Airports Commission shortlisted options
Module 14: Operational Efficiency
preliminary safety review

CAP 1215

LGW 2R - preliminary safety assessment, September 2014**Assumptions**

LHR North West Runway - preliminary safety assessment, September 2014

Figure 1: Gatwick Control Area (CTR)

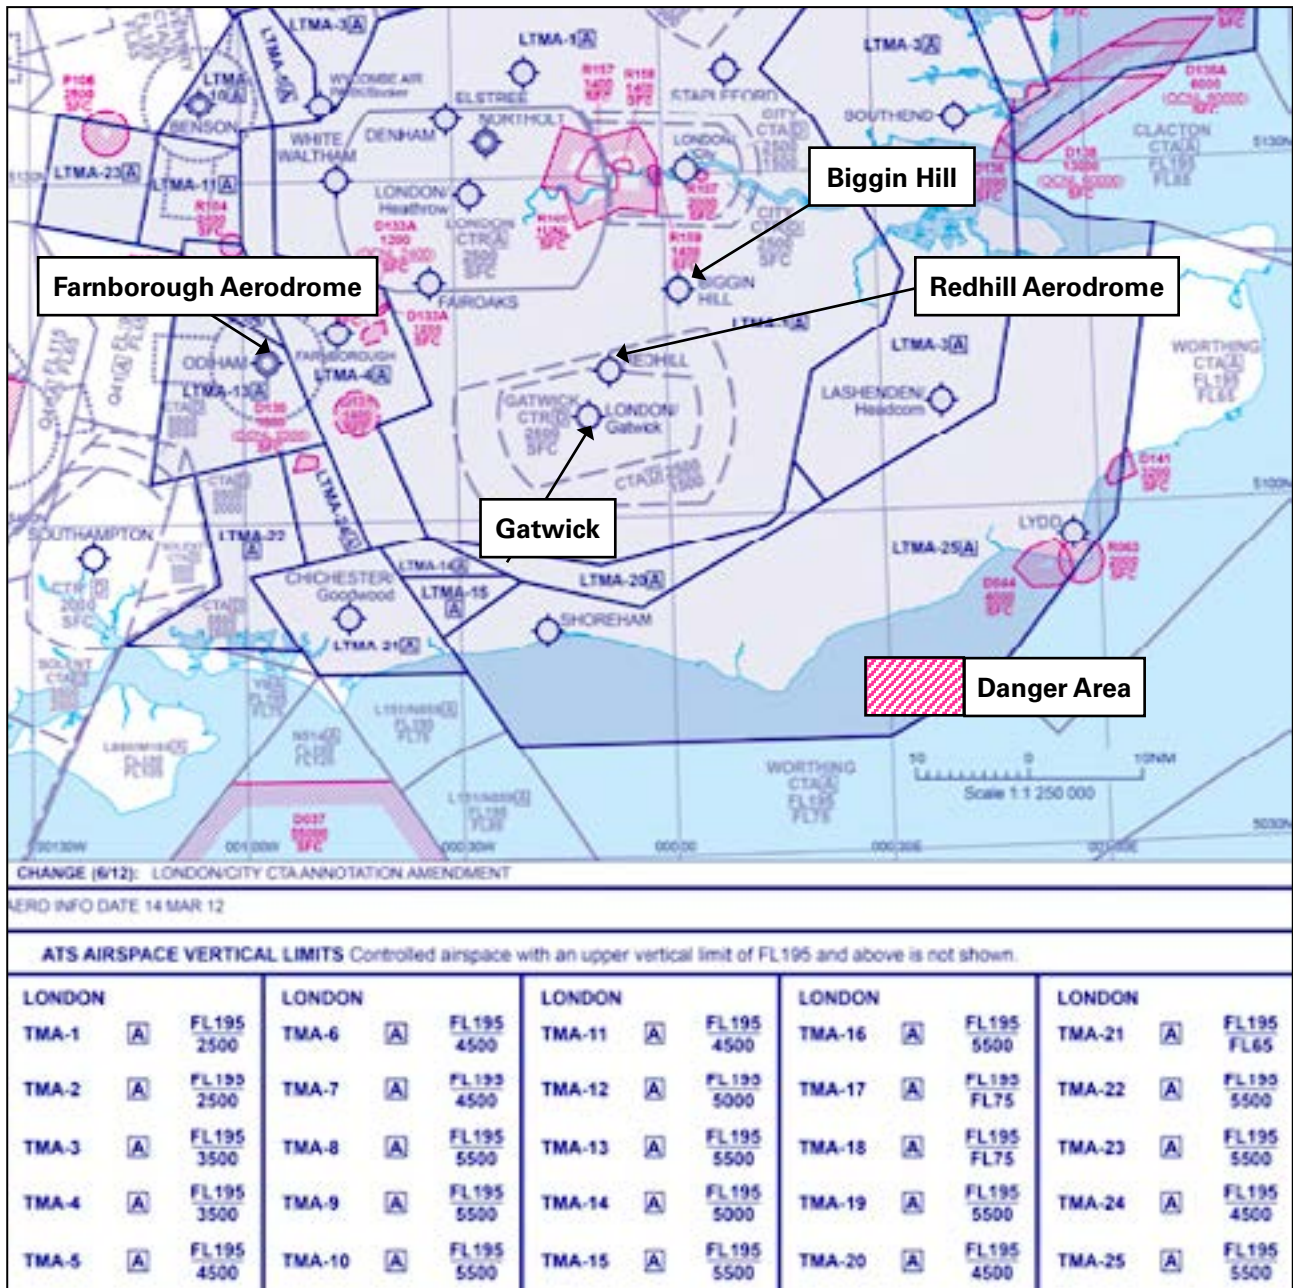
- 2.8 Gatwick is on the Southside of the London Terminal Manoeuvring Area and is sufficiently displaced to the south of Heathrow to have a relatively lower impact on other aerodrome procedures and knock on effects to other airports.

- 2.9 Standard Instrument Departure Routes (SIDs) would need to be redesigned to avoid conflicts associated with having two runways providing arrivals and departures. However, the position of the runways and a compass departure operation is unlikely to be a significant challenge. There is a potential issue of standard arrival routes (STARs) to parallel runways and the transitions flown, with potential for confusion if runway alternation (or Terminal arrivals) is likely to be a feature of the operation - if the existing runway is always the arrival runway this is less of an issue as arriving aircraft would not be required to cross in the air.

2.10 Farnborough aerodrome is currently in the process of developing new procedures and has just completed consultation on a new airspace design. The outcome of this is not yet determined. With revisions to arrival and departure procedures for an expanded Gatwick, there could be requirements for some additional controlled airspace to the west. Until designs are formalised, it is not possible to determine what impact, if any, new Gatwick procedures would have on Farnborough operations. Operations at Shoreham (south of Gatwick) are unlikely to be affected. Redhill (north of Gatwick) and Biggin Hill (north of Gatwick) are unlikely to be affected.

Figure 2: Heathrow Control Area (CTR)

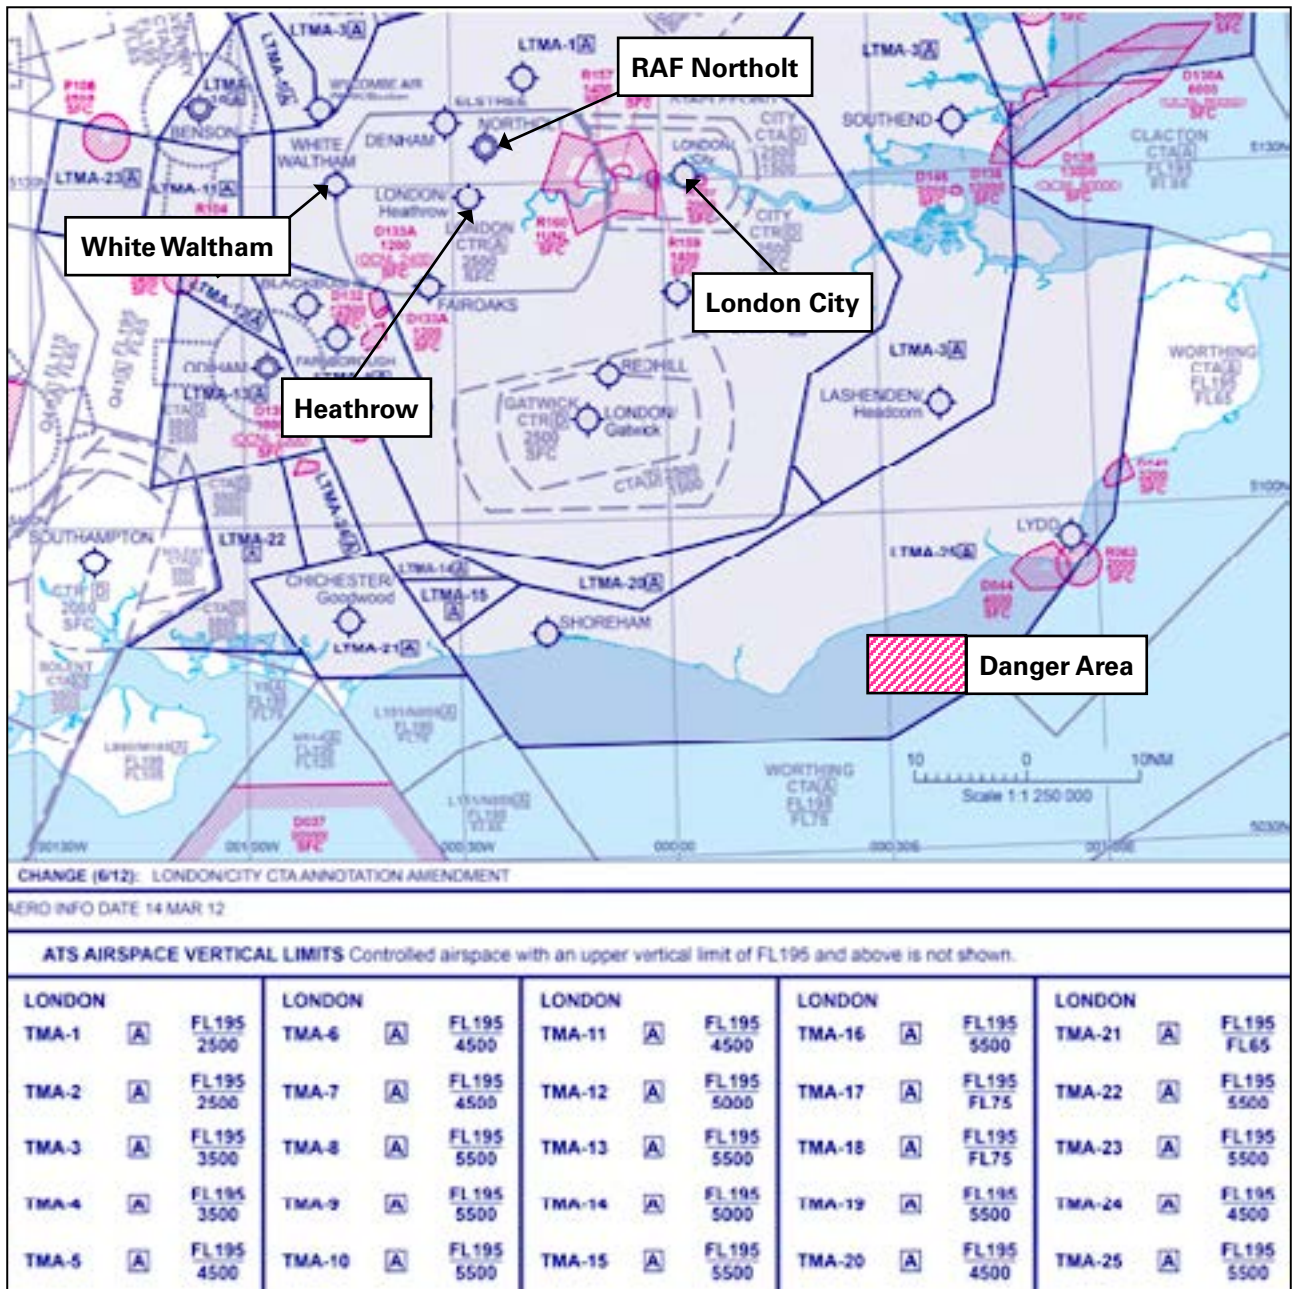
- 2.22 There is currently a lack of detail available at this early stage regarding airspace designs. However, an initial informal assessment of some of the impacts is provided below.
- 2.23 The design is likely to require a dependency with RAF Northolt to ensure safe separations, which could reduce capacity at either or both airports. Any impacts on RAF Northolt procedures need to be understood and assessed.
- 2.24 Missed Approach Procedures for both Heathrow and RAF Northolt remain a major design issue and a major challenge to deliver a safe and operationally effective environment due to close proximity of RAF Northolt and its runway axis (25/07).

2.25 SIDs would need to be redesigned to avoid conflicts associated with having two runways providing departures and the issue of the third runway being further west. It is unclear whether further controlled airspace to the western extremity of the Heathrow CTR is required to accommodate both arrival and departures for the proposal. The impact (if any) on operations at White Waltham and Denham aerodromes is unclear given that flight path vertical profiles are unknown at this stage. The impact on London City operations is also unclear as precise arrival and departure flight paths are unknown at this stage.
